Mr. Hans Jürgen Stehr  
Chair, CDM Executive Board  
UNFCCC Secretariat  
CDMinfo@unfccc.int

April 6<sup>th</sup> 2007

Re Request for review of the request for registration for the CDM project activity "Vikram Cement Energy Efficiency by up-gradation of clinker cooler in cement manufacturing" (Ref. no. 0859)

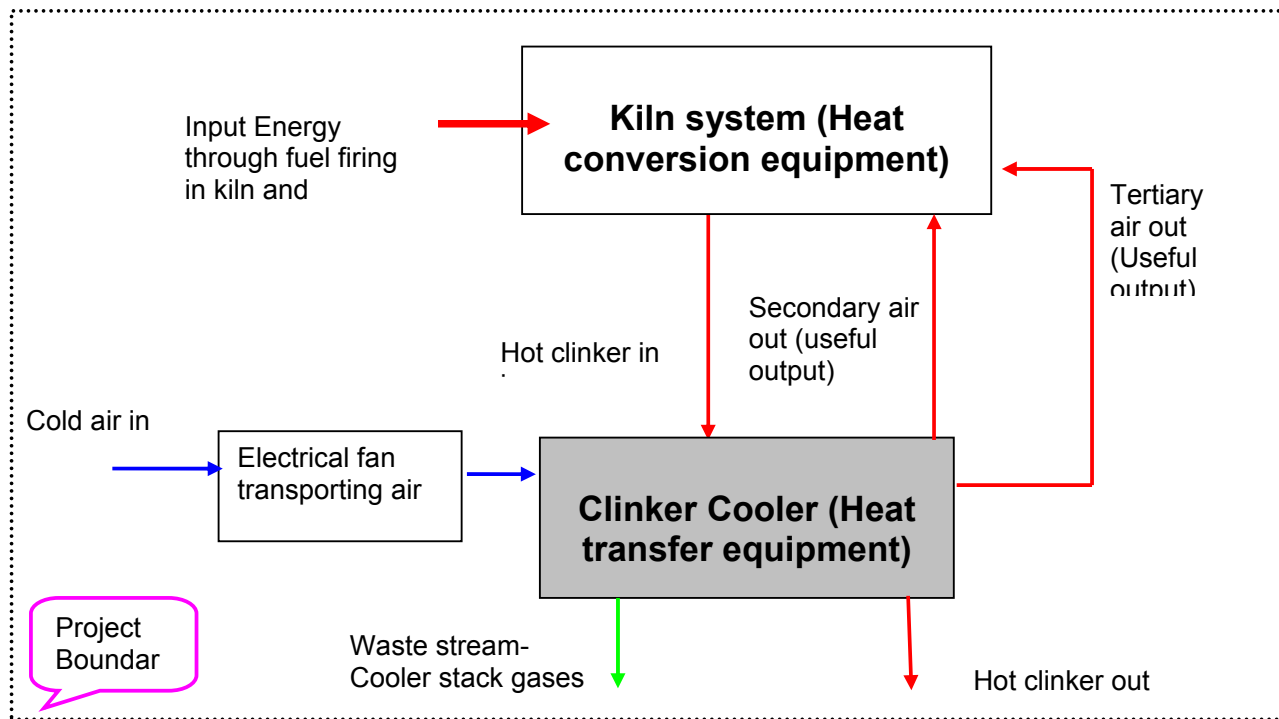
*This project activity uses AMS II D which is a generic methodology for energy efficiency. Vikram Cement was the project participant that submitted large scale methodologies NM0101 and NM0154 for energy efficiency in clinker cooler, both of which were given a C by the Meth Panel. It should be assessed whether AMS II D is correctly applied to this project.*

*As this is not the first time this issue comes up, the Board may wish to ask the SSWG to review whether the concerns expressed by the Meth Panel with respect to the above not approved large scale methodologies need to be addressed by AMS II D.*

From the project activity is in cement sector and the sector is complex in nature. Although all the parameters monitored in the project activity are in general practice in cement industry. Based on the number of parameters the calculation may look complex but it is simple based on the institutional as well as industrial standards.

Heat Balance Approach - In the project activity all the parameters used are continuously monitored parameters and the quality of products depends on those parameters. The project proponent has its brand value and needs to produce consistent quality of product. To ensure consistent quality, the parameters will be more or less within the acceptable range of variations. The approach adopted is same for baseline and project scenario and the small variations are averaged out in determination of baseline efficiency. In this manner the calculation performed in the project activity will be as per the established practice in cement sector and will be within the acceptable variation.
